RIVERBEND CROSSING
FILING NO. 1
STREET, STORM, & STRIPING
CONSTRUCTION DRAWINGS

RIVERBEND CROSSING FILING NO. 1 STREET IMPROVEMENT, STORM SEWER, AND SIGNAGE & STRIPING CONSTRUCTION DRAWINGS

PCD FILE #: SF1844

SOUTHMOOR DRIVE WIDENING DETAIL - URBAN RESIDENTIAL COLLECTOR

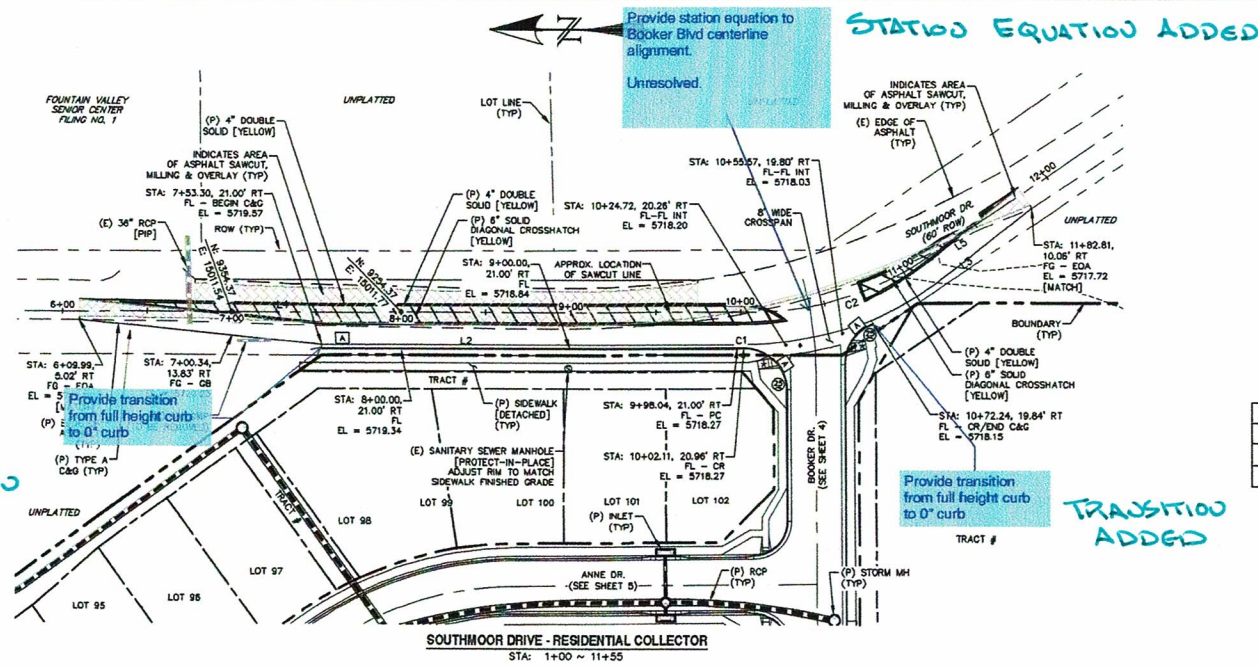
TRANSITION
ADDED

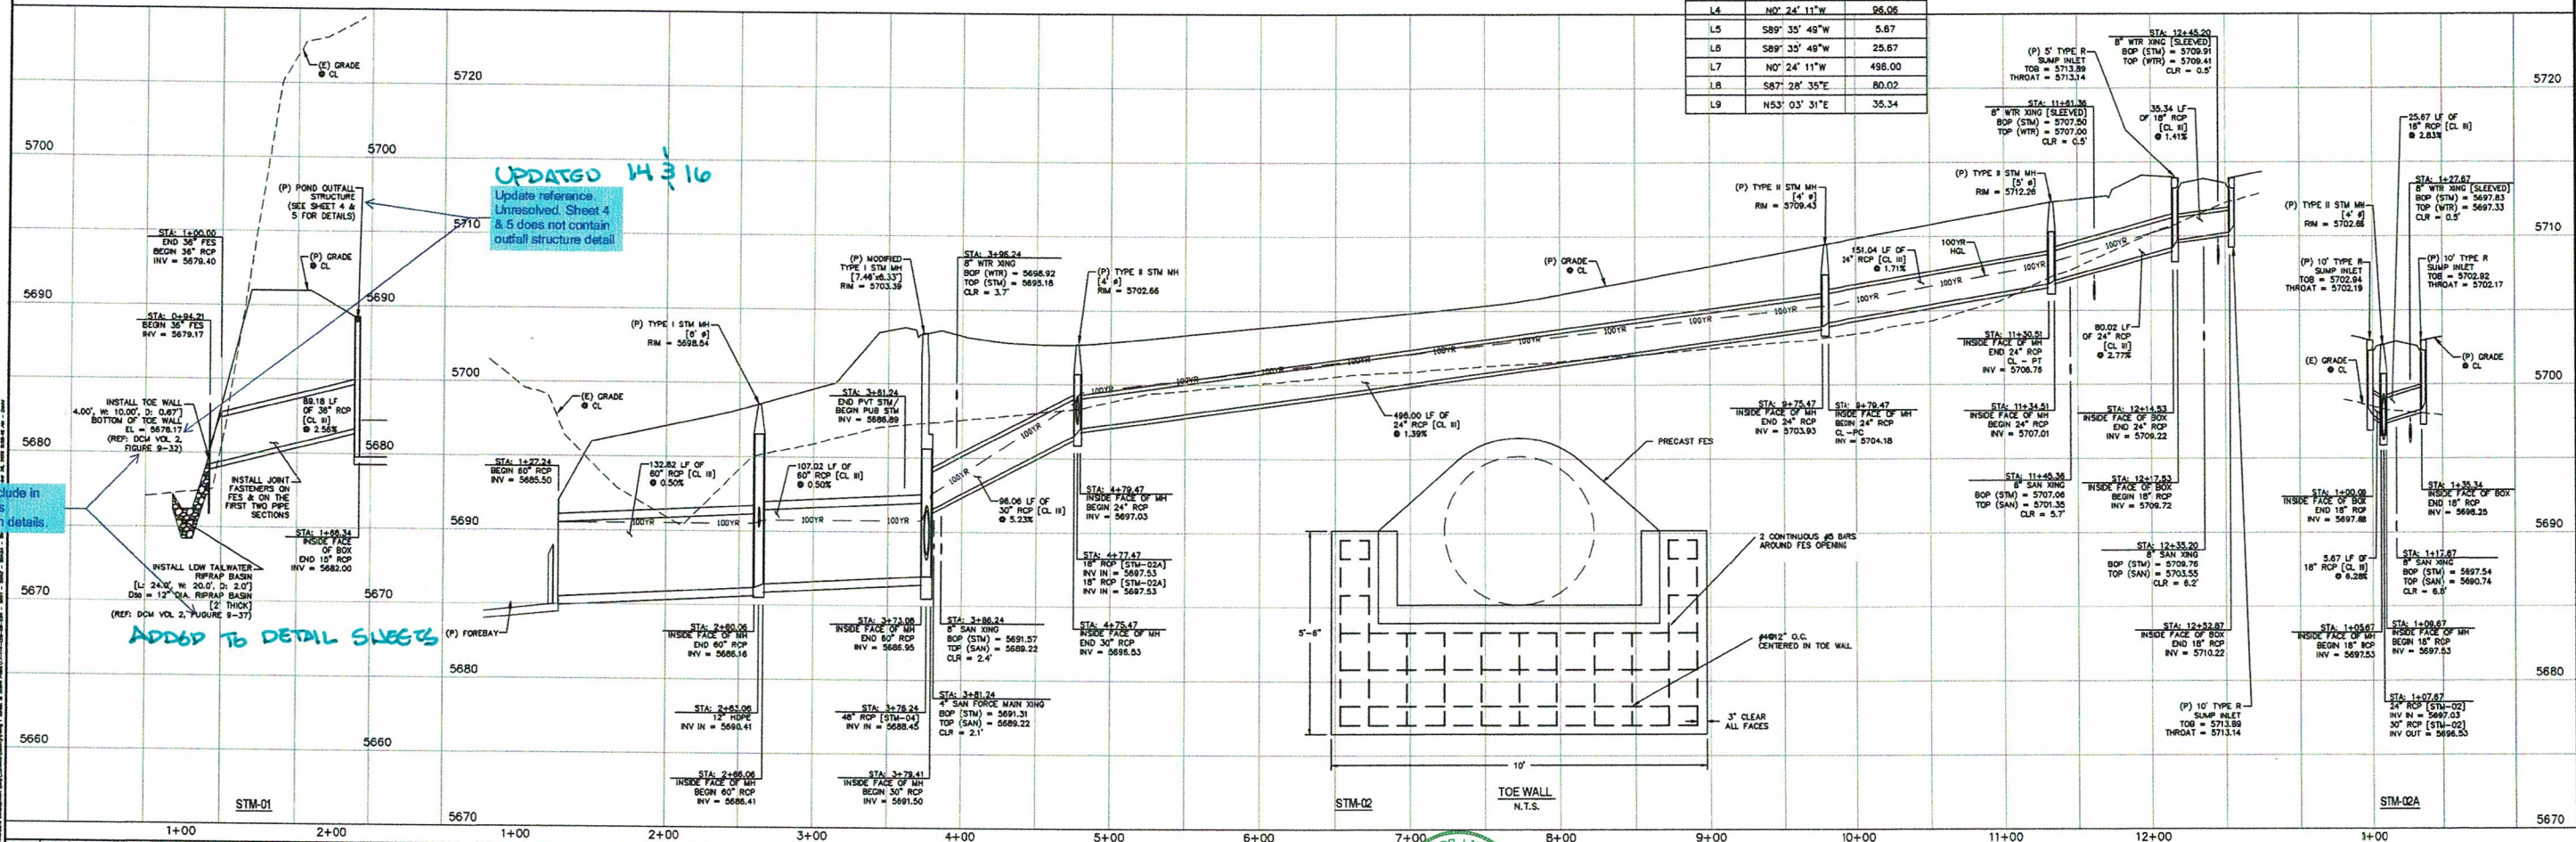
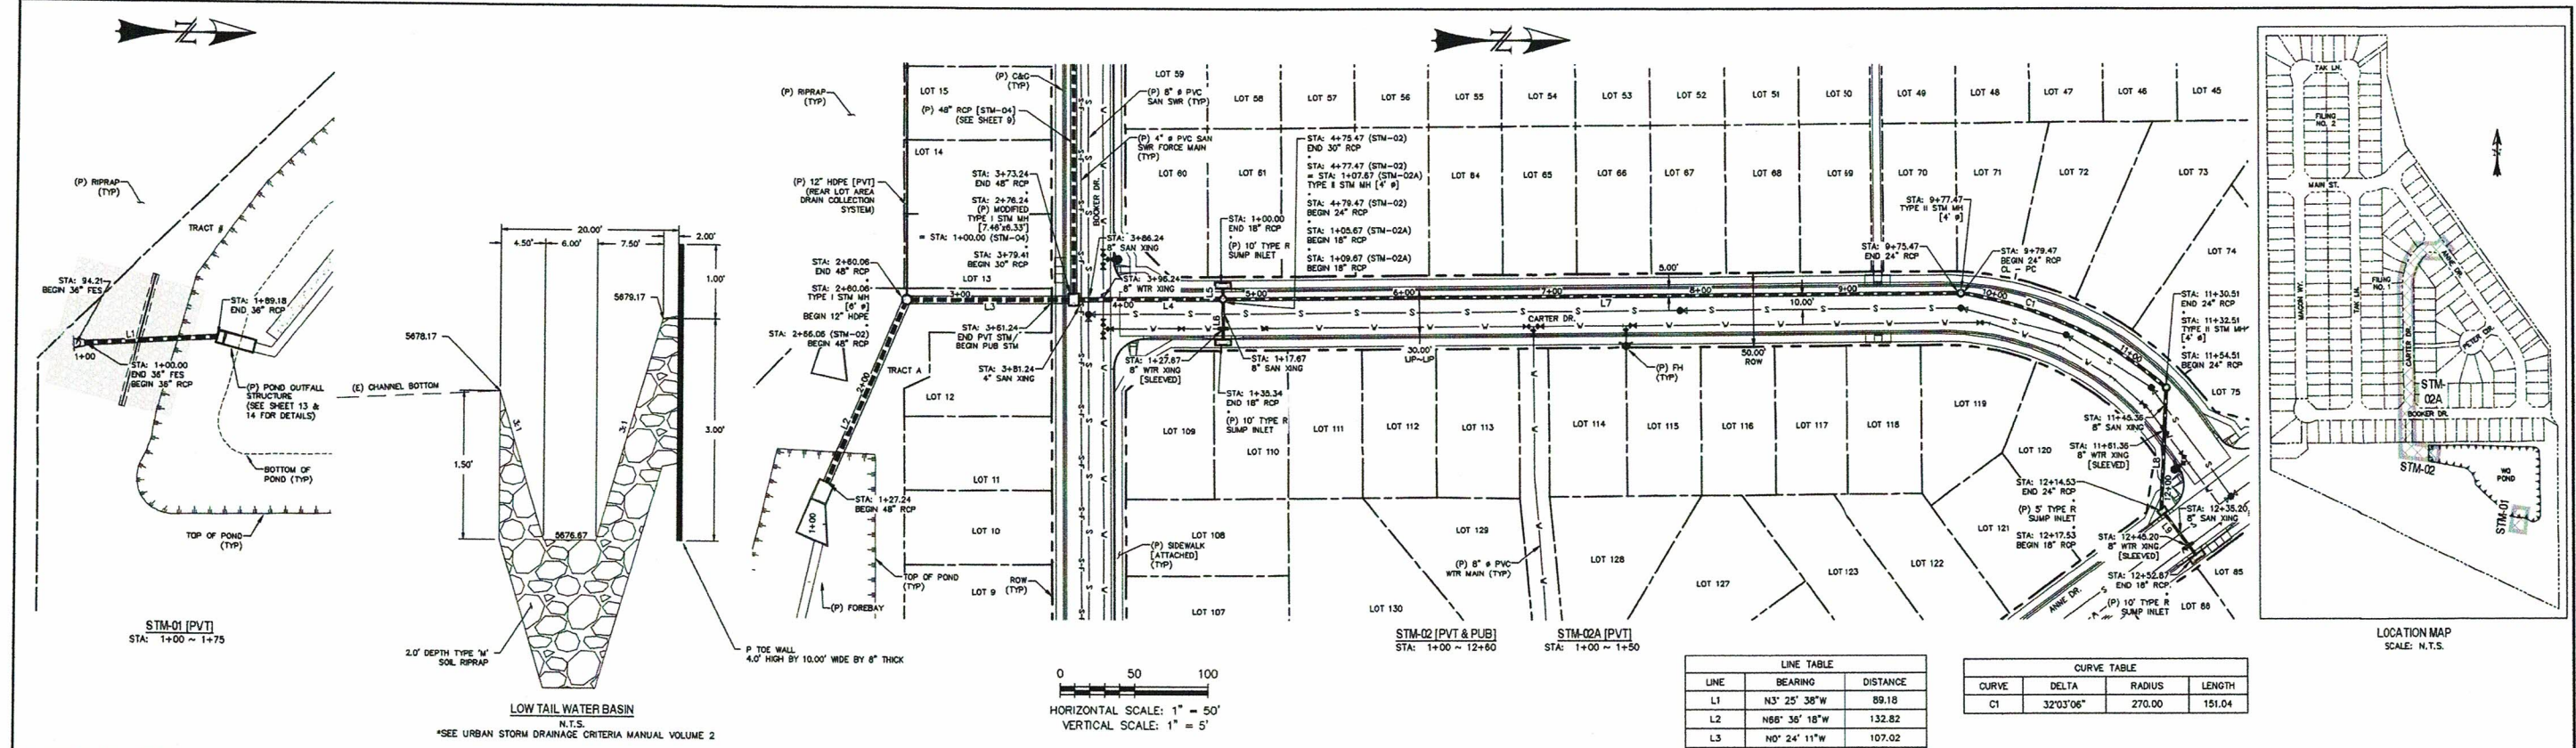
UPDATED 14/3/16
Update reference
Unresolved Sheet 4
& 5 does not contain
outfall structure detail

Revise include in
the plans as
construction details.

ADD TO DETAIL SHEETS

RIVERBEND CROSSING
FILING NO. 1
SIGNAGE & STRIPING PLAN

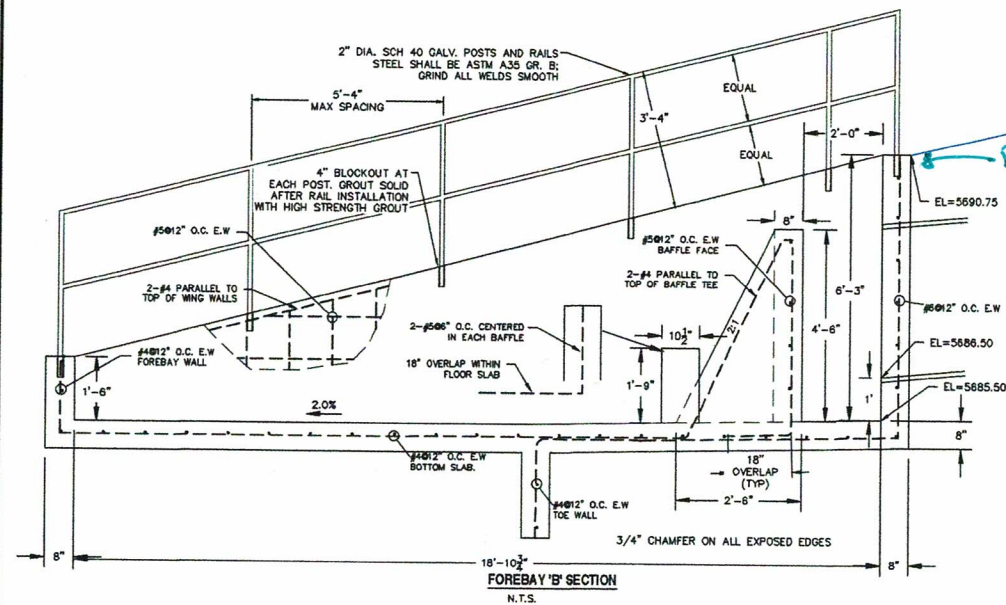
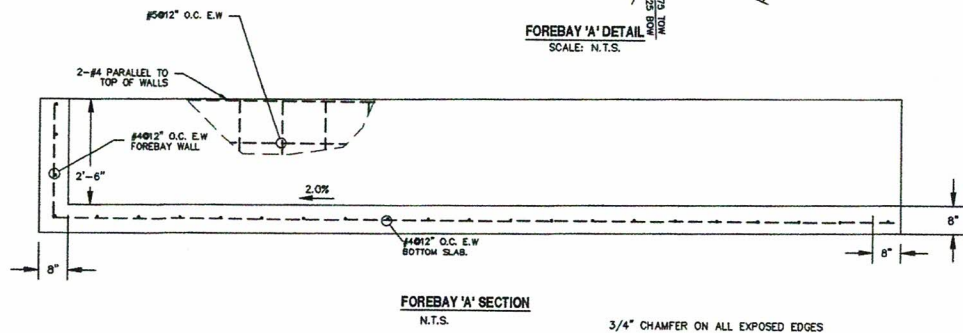
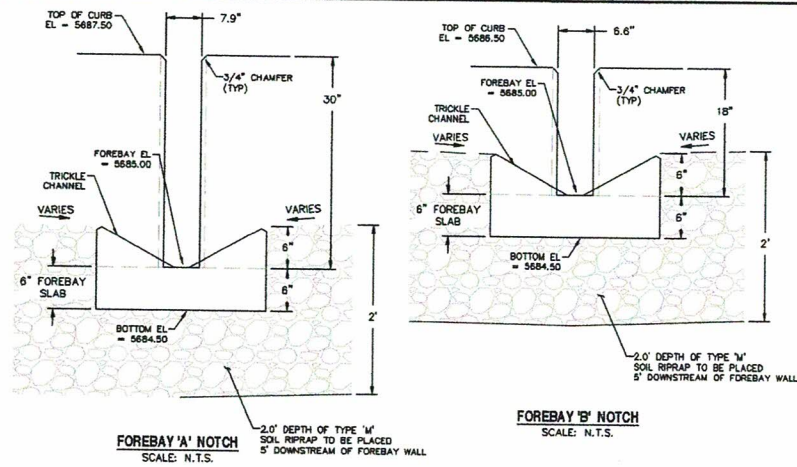
Based on projected 2040 total traffic volumes and the criteria contained in the El Paso County Engineering Criteria Manual (ECM), a northbound left-turn deceleration lane would not be required on Southmoor Drive approaching the proposed residential full-movement site access point, as the projected turning volume is below the ECM threshold volume requiring a left-turn deceleration lane. However, Figure 18 shows the recommendation to extend the Non-Residential Collector cross section to a short distance south of the access point. With the Non-Residential Collector cross section extended south of the access, a short northbound left-turn bay suitable for northbound left-turn vehicle stacking and alignment with the southbound left-turn lane would be striped as part of the cross section of the street. The lane-transition taper could be embedded within the redirect tapers south of the intersection.

REVISED PER AGREEMENT
@ PRELIMINARY PLAN
FINAL SUBMITTAL

This does not appear to meet the Traffic Study recommendation to provide a short northbound left turn bay. Coordinate with the traffic engineer

update per Fountain engineering comments (See email dated 10/23)

RIVERBEND CROSSING
FILING NO. 1
EXTENDED DETENTION BASIN

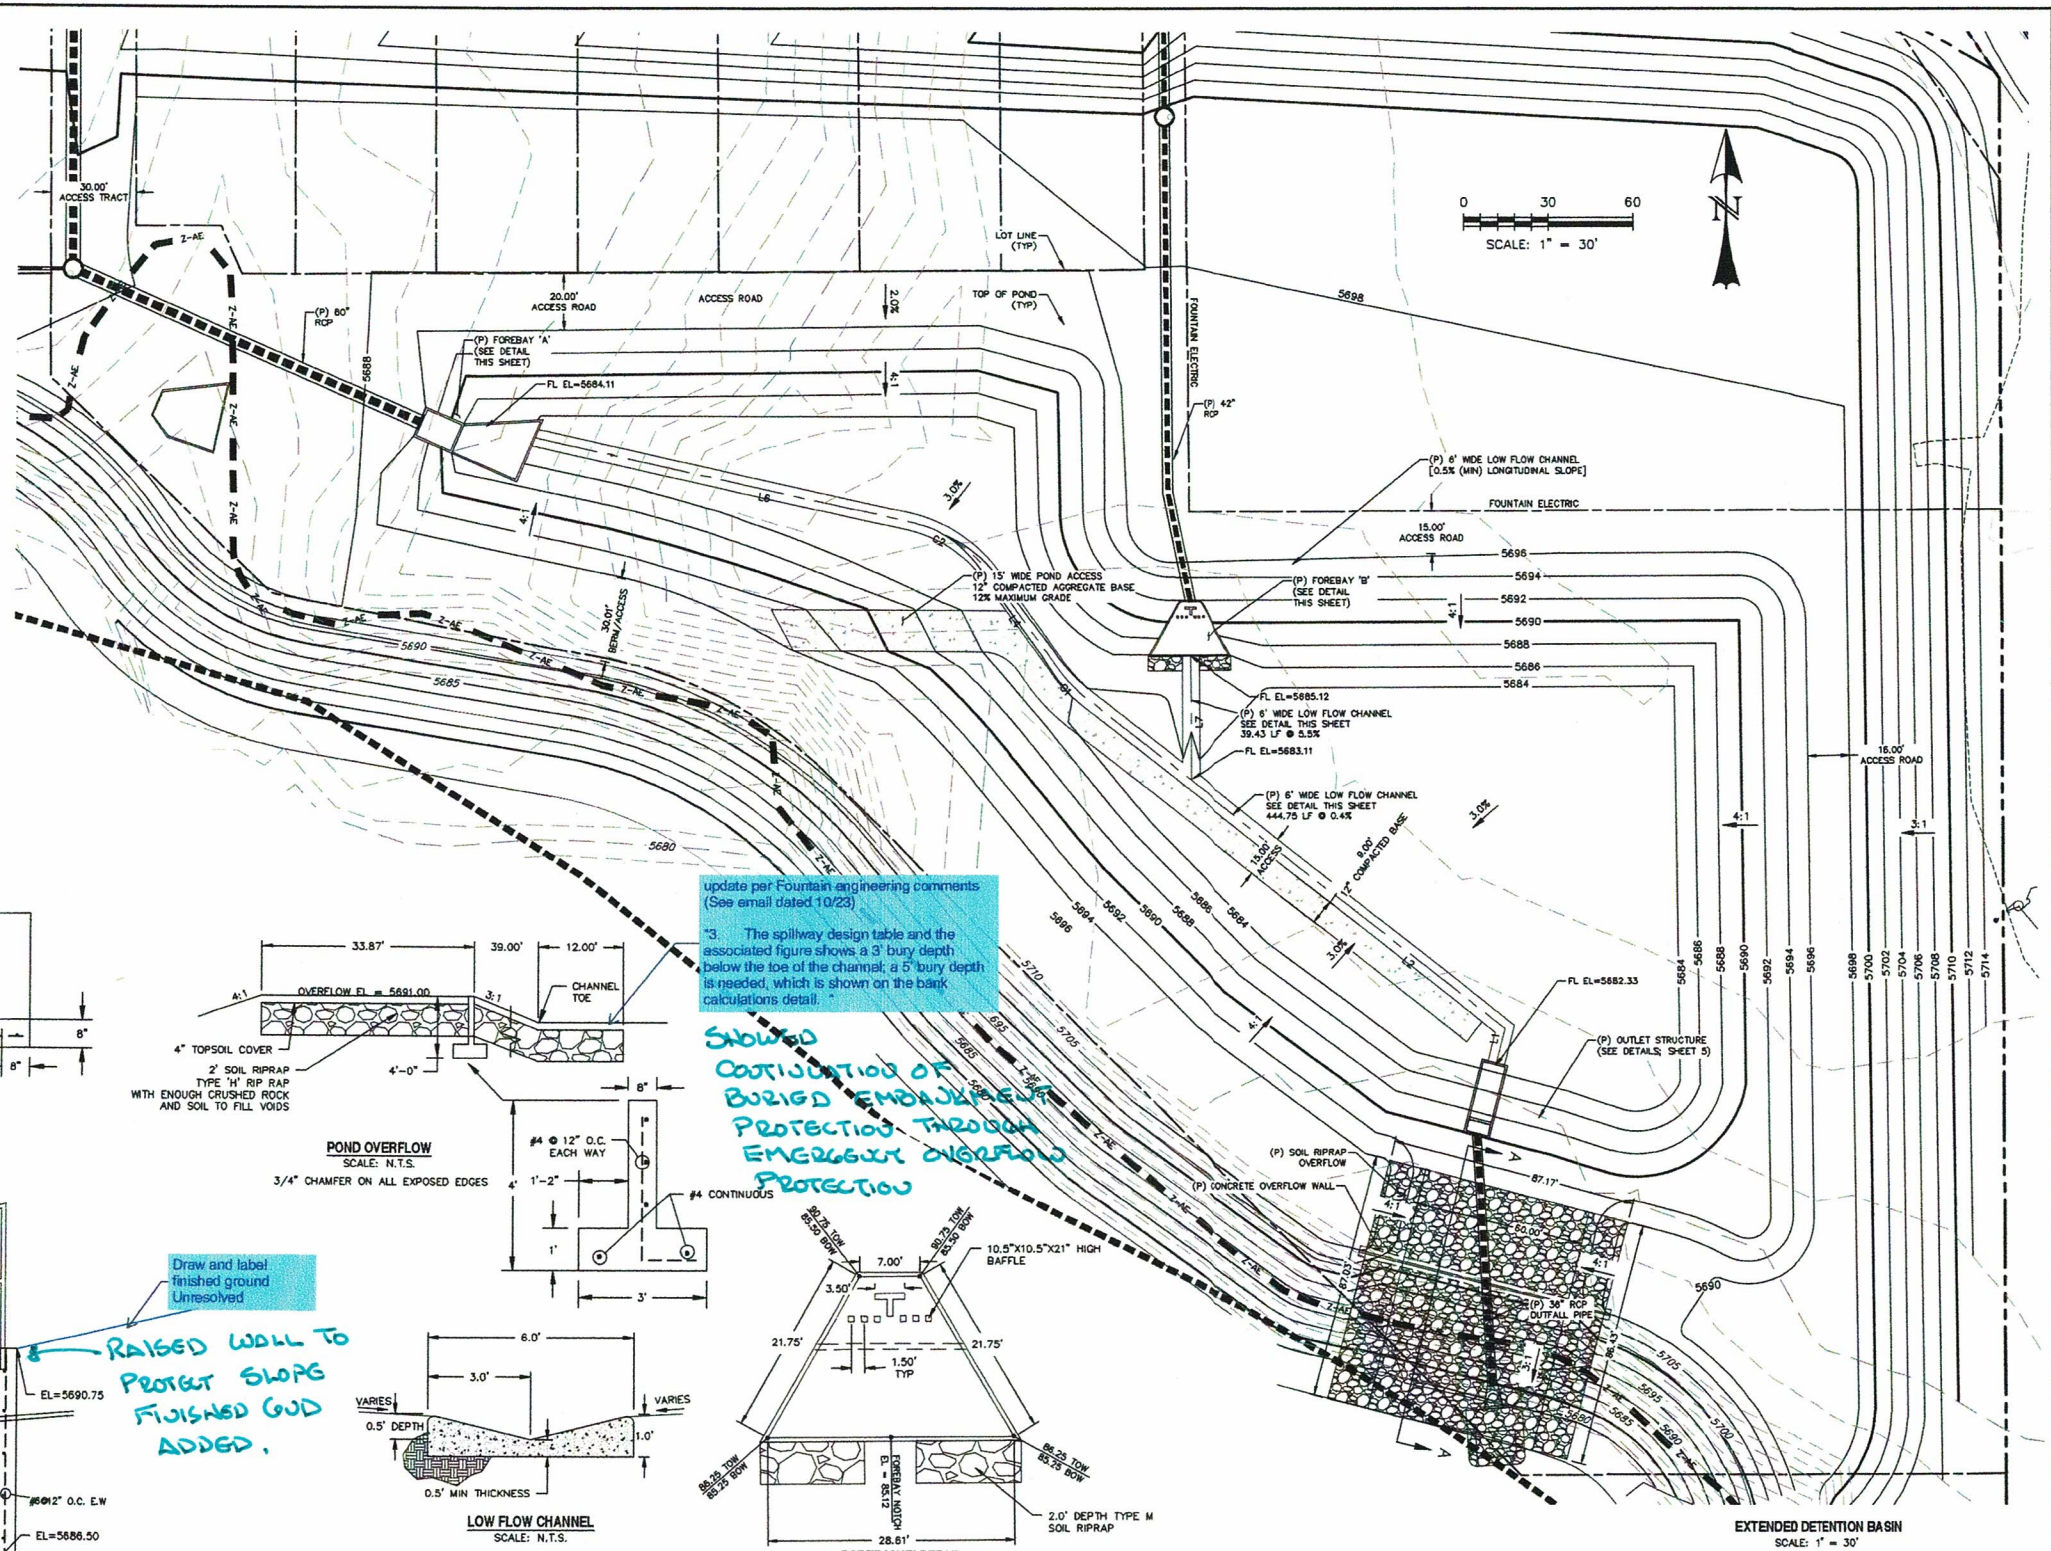
"3. The spillway design table and the associated figure shows a 3' bury depth below the toe of the channel, a 5' bury depth is needed, which is shown on the bank calculations detail."

SHOWN
CONTINUATION OF
BURIED EMBANKMENT
PROTECTION THROUGH
EMERGENCY OVERFLOW
PROTECTION

RAISED WALL TO
PROTECT SLOPE
FINISHED GUD
ADDED.
